HISTORIC AND DESIGN REVIEW COMMISSION

Agenda Item No: 20

HDRC CASE NO: 2016-279
ADDRESS: 630 E GUENTHER ST
LEGAL DESCRIPTION: NCB 939 BLK 2 LOT 12
ZONING: RM4 H HS
CITY COUNCIL DIST.: 1
DISTRICT: King William Historic District
LANDMARK: Meerscheidt House
APPLICANT: Catherine Nored/Nored Architecture
OWNER: Linda Couch
TYPE OF WORK: Front yard fencing
REQUEST:

COUCH STUDIO - 630 E. GUENTHER ST.

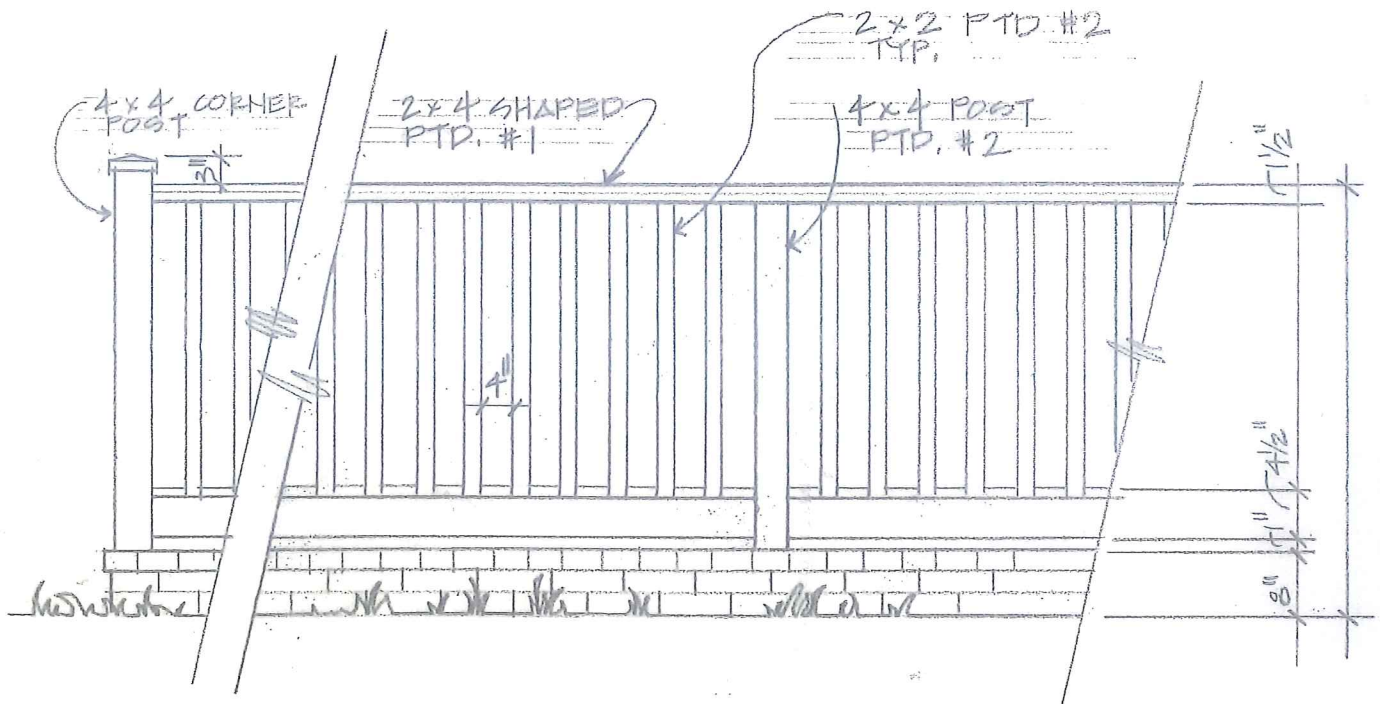
- b. According to the Guidelines for Site Elements 2.B.i., new fences and walls should appear similar to those used historically within the district in terms of their scale, transparency and character. The applicant has proposed plum mahogany fence which sits atop a brick base of approximately eight (8) inches in height. There are examples of historic fences throughout the King William Historic District of wood fences that are atop a brick base. Staff finds this proposal appropriate.

- d. While the applicant's proposed materials are appropriate, staff finds the overall design of the fence inappropriate. Historic fences throughout the King William Historic District, regardless of material, rarely feature a horizontal

element serving as a cap. As it is constructed, the front yard fence features elements that resemble a porch railing. Staff recommends the applicant redesign this element of the fence.

- i. That the applicant remove the horizontal cap element and introduce a traditional picket element.
- ii. That the applicant maintain a fence with one (1) finish color.
